**Assessment of Five (5) Protected-Size Trees
at
15 Loma Alta
Los Gatos, California**

Prepared for:
Jennifer Armer, Senior Planner
Town of Los Gatos Community Development Department
110 E. Main Street
Los Gatos, CA 95030

Report by CTA
9/2/2019

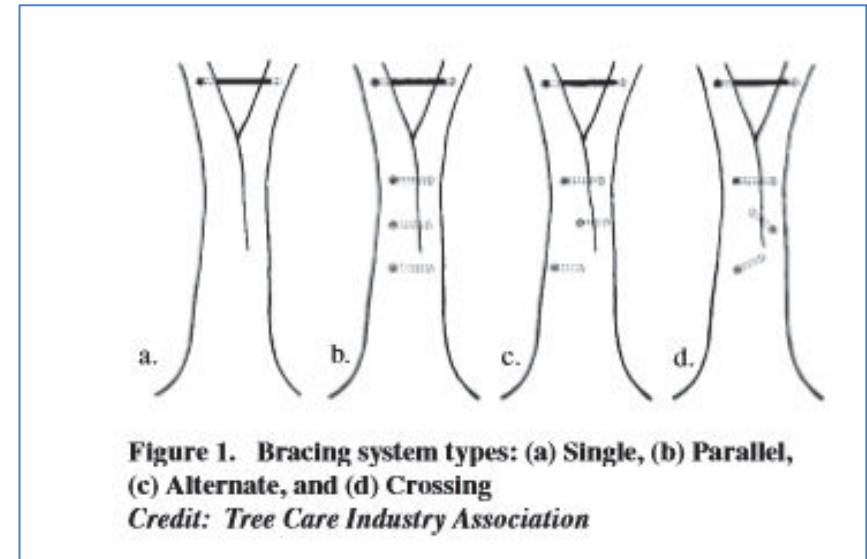
2e. Tree #4: (Optional) Install a through-bolt bracing system (see sample image at right¹) at the bark inclusion type fork at the codominant mainstem system attachment zone located in the lower trunk area of the tree. Install through-bolt bracing rods per the specifications noted in the most recent edition of:

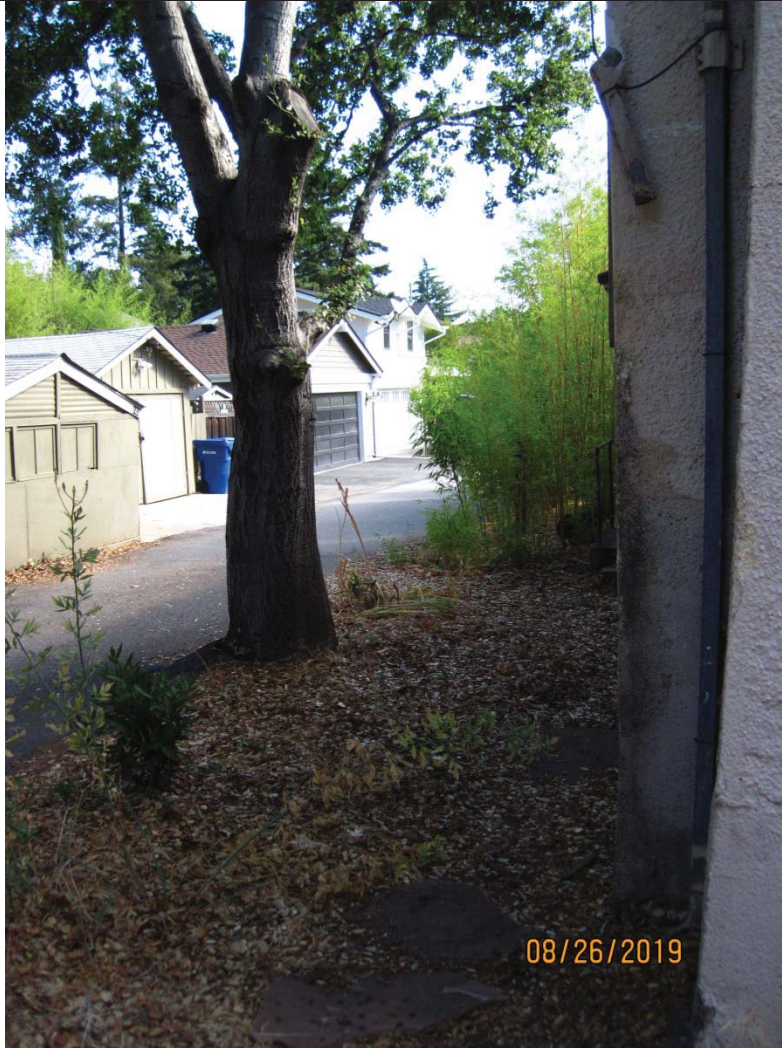
Note the narrow fork attachment angle at the lower trunk area of oak #4. The CTA suggests optional installation of through-bolt bracing per ANSI A300 specifications to support this fork.
